REPORT FOR  
**BIRCH HILL RUN SUBDIVISION  
PLAN REVISIONS**

**Environmental Review Team Report**

Washington Inland Wetlands Commission

**JANUARY 1991**

## Proposed Site Plan

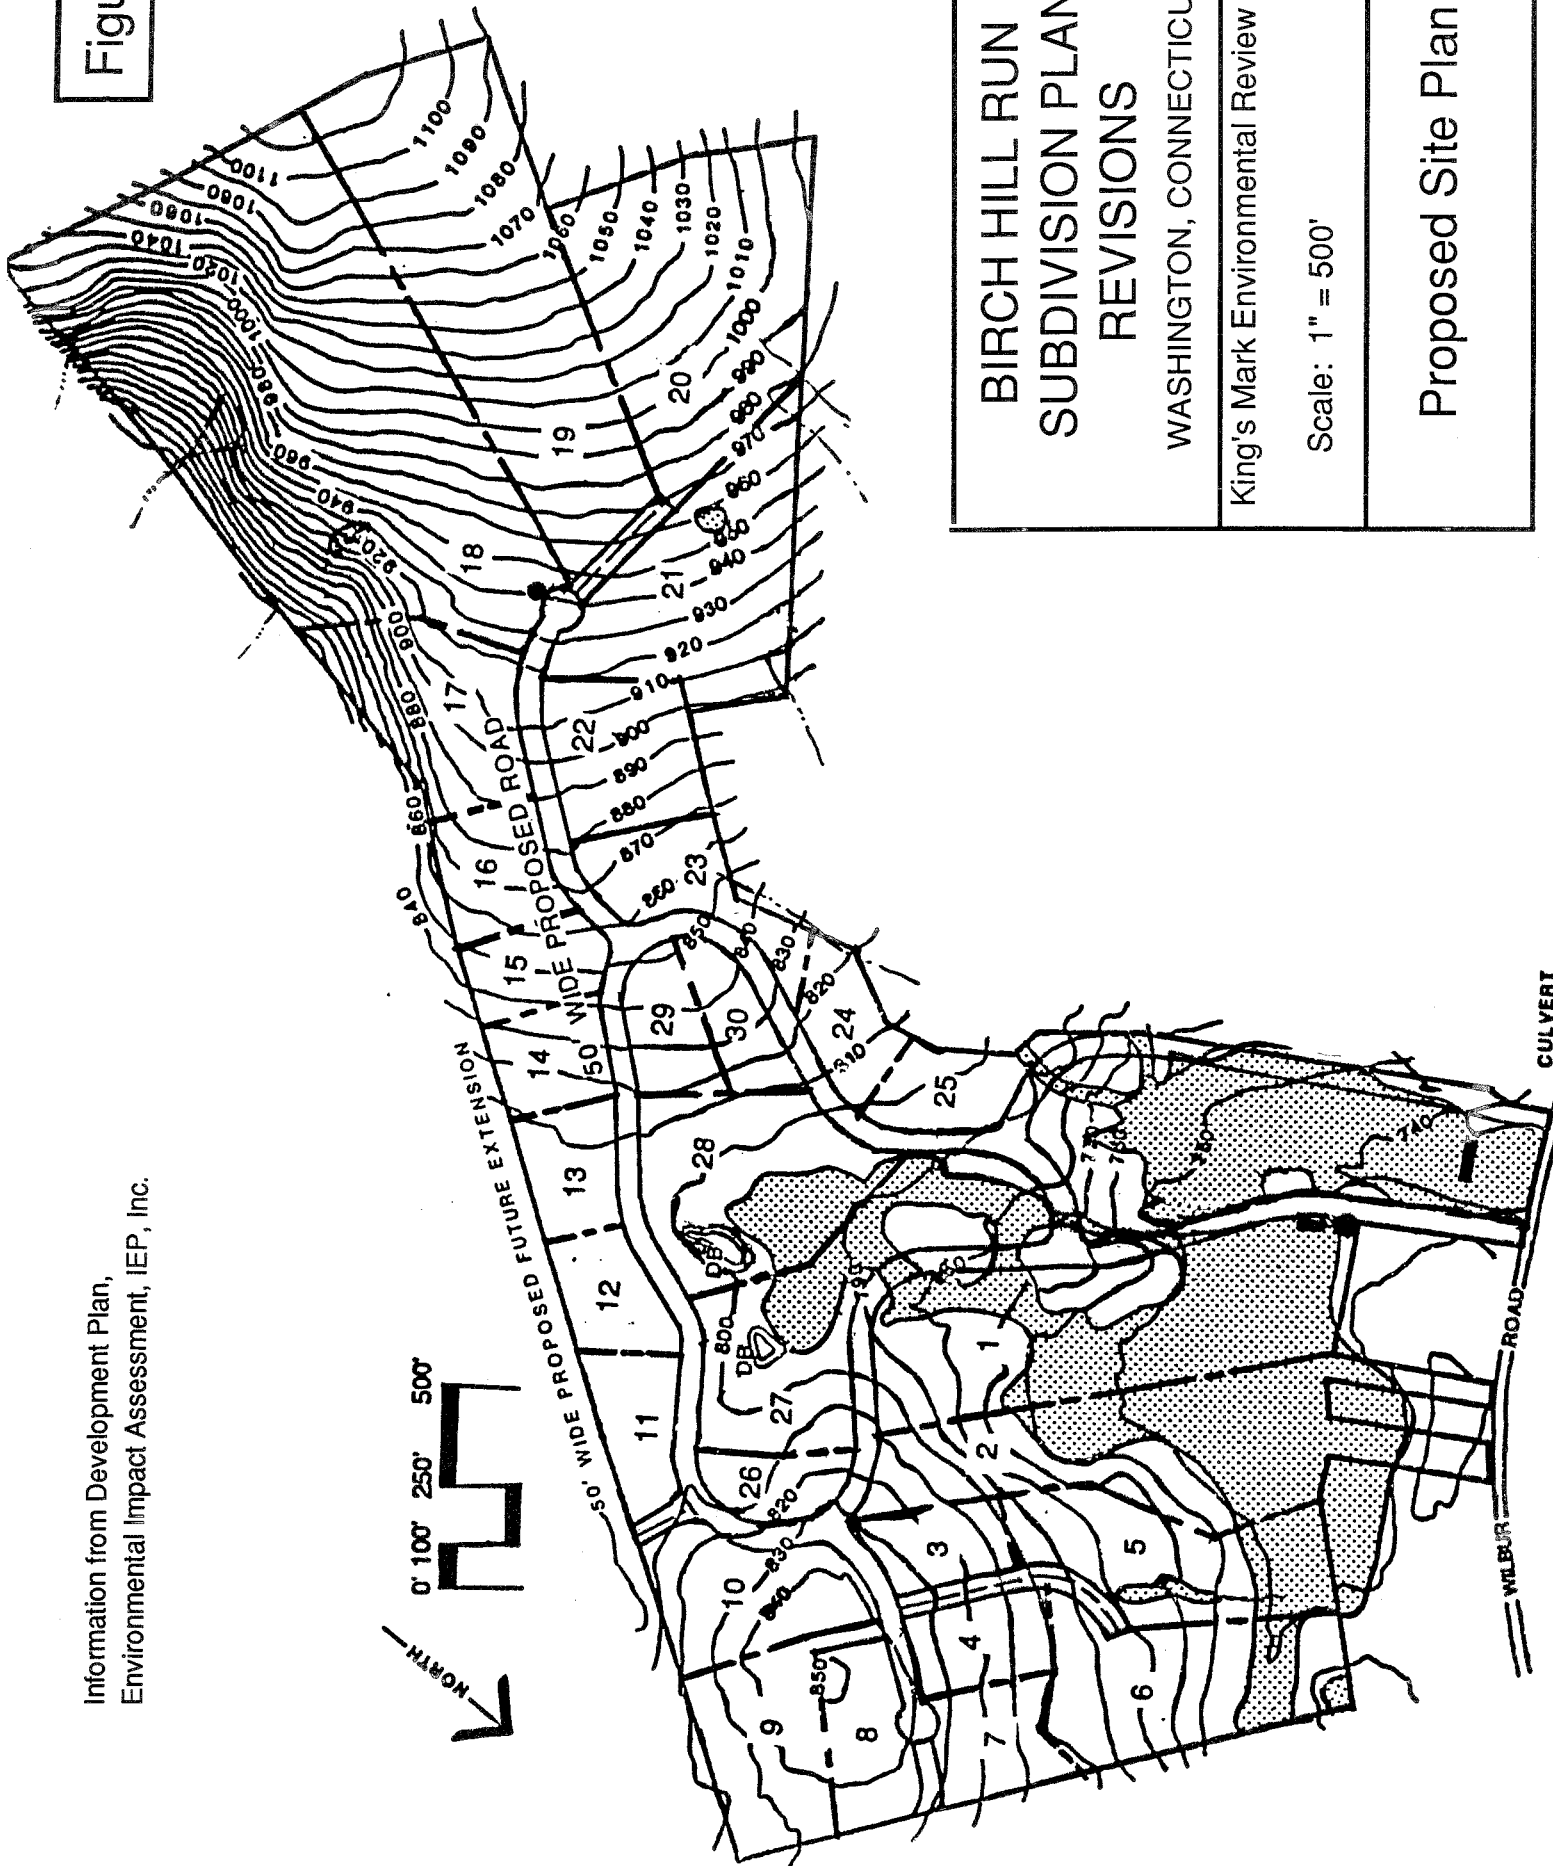
The proposed subdivision uses curbed roadways and collected roadway runoff for most of the road areas. This has the disadvantage of concentrating the roadway runoff, which then must be spread out in the wetlands. Non-curbed roadways and roadside swales should be used in all areas where practical. Much of the roadway area to the north of the powerlines can be curbless as well as some of the more level areas of roadway to the south of the powerlines.

The construction of 2 improved roads to the site from Wilbur Road will have a much larger impact on the wetlands than is necessary. The Town should consider the option of constructing one new road along the westerly site boundary and keeping the existing woods road as an unpaved emergency vehicle access route.

The earlier ERT report (March, 1990) for this site noted that 7 lots, as designed, will require use of pumping chambers to raise waste water to the leaching fields. The current subdivision proposal contains 11 lots which are designed with leaching fields uphill from the house, namely Lots 1-3, 5, 6, 8 and 16-20. On a number of these lots the leaching field is directly uphill from the house or well or both. These comments apply:

- 3) It seems less than optimum design, especially on a large lot subdivision, to place leaching fields directly uphill from house and well sites. Waste water from the leaching fields moves downward and downhill through the ground materials. A house basement or well located directly downhill from the leaching field is much more likely to be affected by waste water from the leaching field. Lots 2 and 16 are examples of this type of situation. Many of the 11 lots with uphill leaching fields could have these problems. The leaching fields should be located so that down-slope movement of waste water is not directed at basements or wells. Lots 7, 9, 26 and 27 show better placement of facilities.

Mount Rat is a scenically prominent feature of the Town. Consideration should be given to a pedestrian access from this subdivision towards the summit of Mount Rat. A 10-foot pedestrian access could be created off of Birch Hill Run between Lots 15 and 16 or between Lots 16 and 17. This access could continue along the southern part of Lot 18 uphill towards the summit of Mount Rat. In the long-term this could link up with other pedestrian access ways, if available, to the top of the hill and/or down the slope to the Shepaug River, resulting in a very desirable hiking trail. The inclusion of such access ways should be done during the planning approval of each subdivision plan.

Run West and East, the roads could be combined into a single access roadway, Birch Hill Run West, which will reduce the impact on the existing wetland system. This will require an adjustment to the first connecting subdivision roadway from Wilbur Road. A single 24-foot wide paved roadway would be adequate to serve the subdivision. A single 30-foot wide roadway would provide adequate width in case of an emergency.
